CITY OF MADISON
CITY ENGINEERING DIVISION
DEPARTMENT OF PUBLIC WORKS
PLAN OF PROPOSED IMPROVEMENT
PHEASANT BRANCH GREENWAY ENHANCEMENT

CITY PROJECT NO. 14370

ADDENDUM #2
REVISED THE FOLLOWING:
SHEETS D1-D3
SHEETS EC1-EC4
SHEETS G13, G15, G112
SHEETS P1-P19, P21, P24-27
SHEETS U1-U18, U22
SHEETS E1-E6
SHEET PM1
SHEETS X32A-X34, X45-X48

REVISION 2
SHEET EC1-EC2
SHEETS P9, P13, P14
SHEETS U1, U5, U9, U11, U16, U19, U21
SHEETS X18-X19, X48

UTILITY PLAN AND PROFILE - DEMING WAY

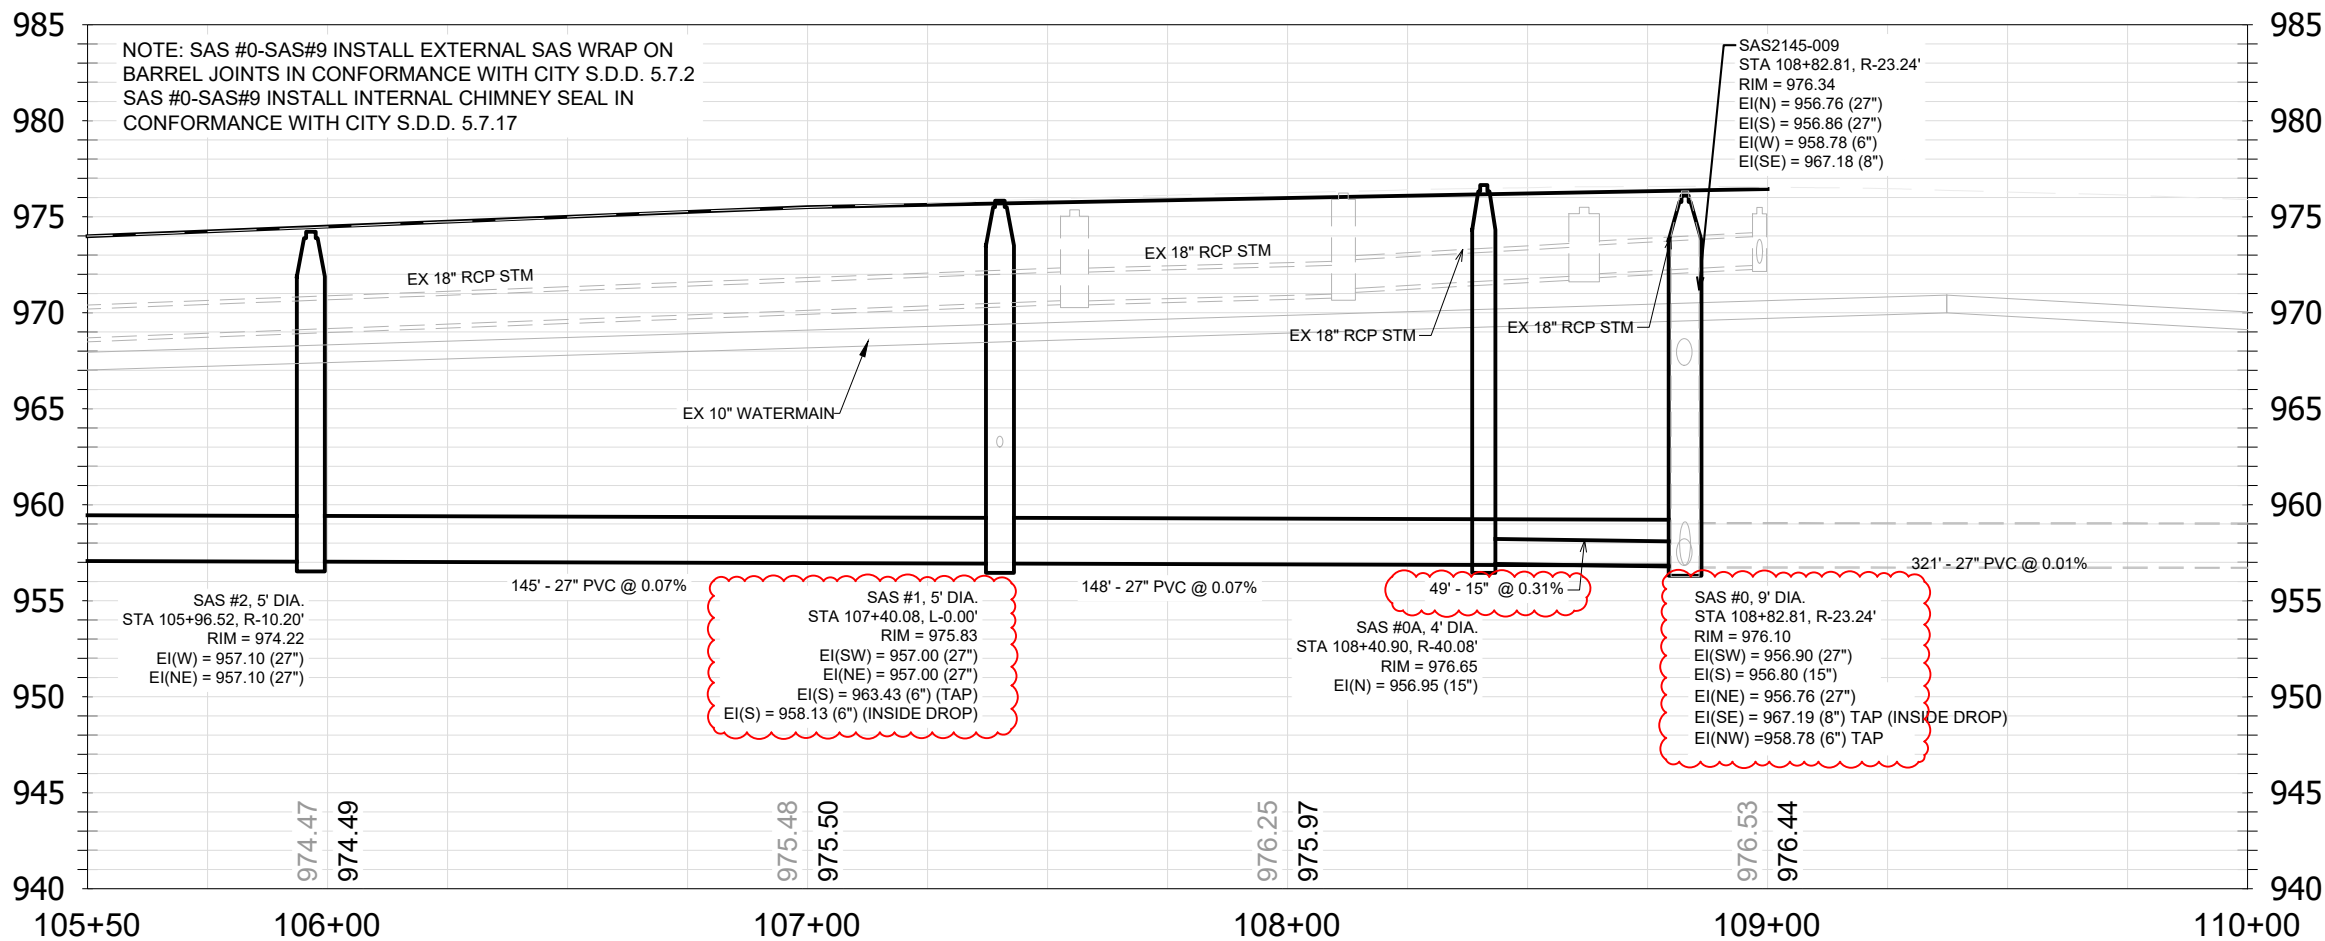
- REVISION NO. 2
1. UPDATED 1289 DEMING SANITARY SEWER CONNECTION NOTE.
 2. REVISED SIZE OF SANITARY PIPE BETWEEN SAS #0A AND SAS #0 IN PROFILE VIEW.
 3. REMOVED SAS #0 EI(W) INVERT.
 4. REVISED SAS #1 STRUCTURE INVERT NOTE.
 5. REVISED SAS #1 PROPOSED LATERAL NOTE IN PLANVIEW.

UTILITY PLAN AND PROFILE - DEMING WAY BOX CULVERTS

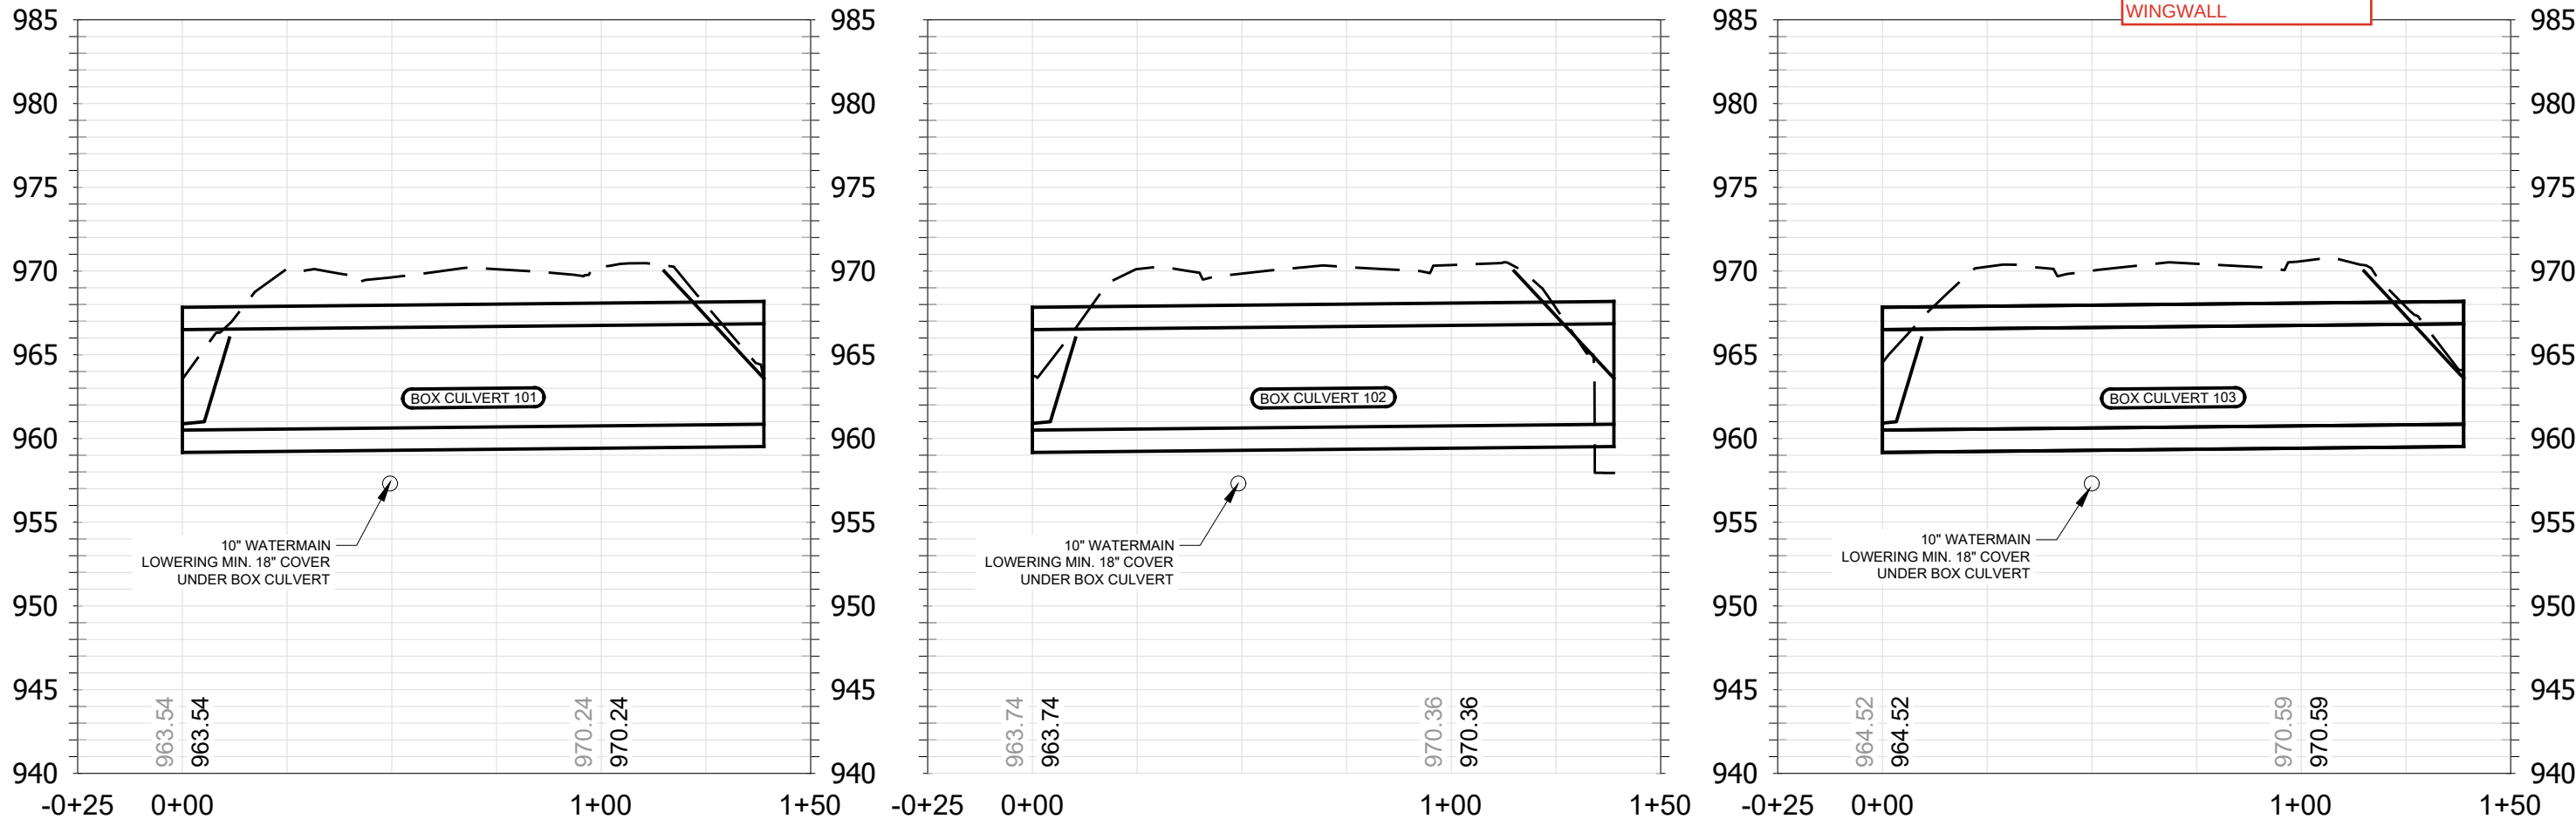
REVISION 2:
EXTENDED RIPRAP TO
TOP OF WINGWALL TO
ACCOUNT FOR STEEP
SLOPE ON TOP OF
WINGWALL

PROJECT NO.	14370
CITY OF MADISON	
PROJECT NAME	PHEASANT BRANCH GREENWAY ENHANCEMENT
LOCATION	MADISON, WI
CONTRACT NO.	9517
DESIGNED BY	GMA
DATE	11/7/2024 10:59 AM
REVISION	
MARK	
BY	
DATE	11-30
Scale:	1"=30'
Sheet	E-1

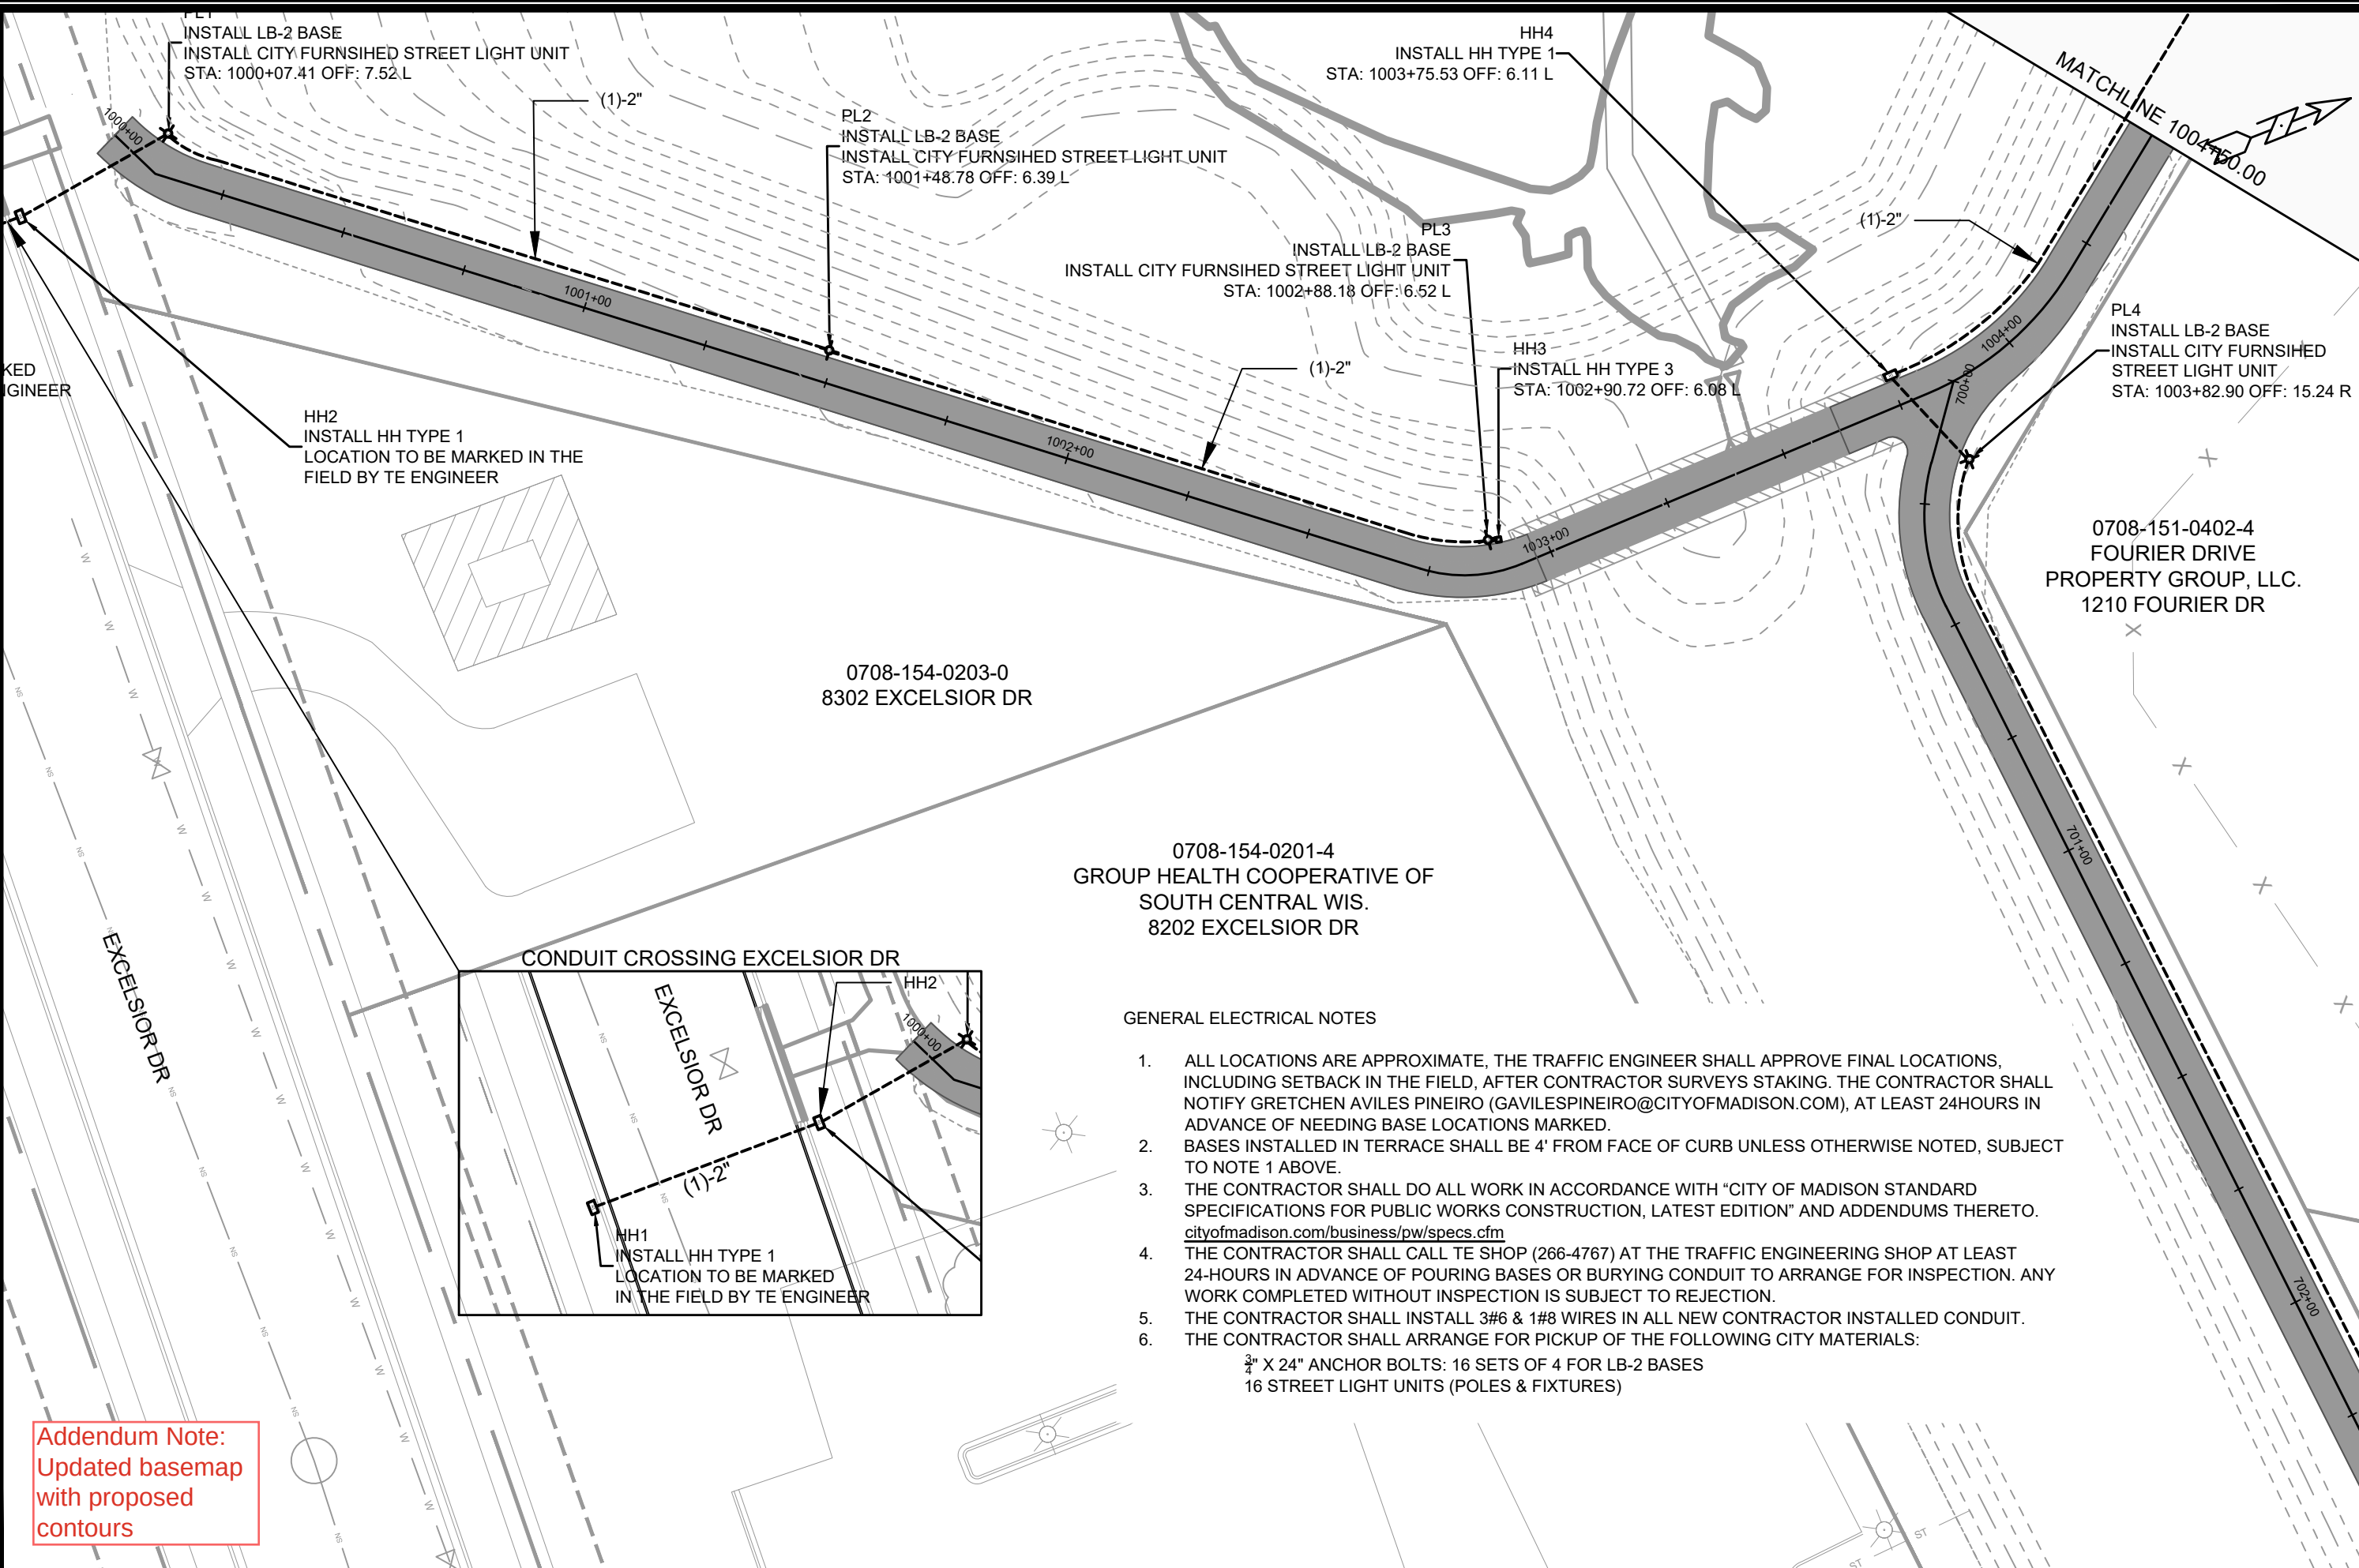
Addendum Note:
Updated basemap
with proposed
contours
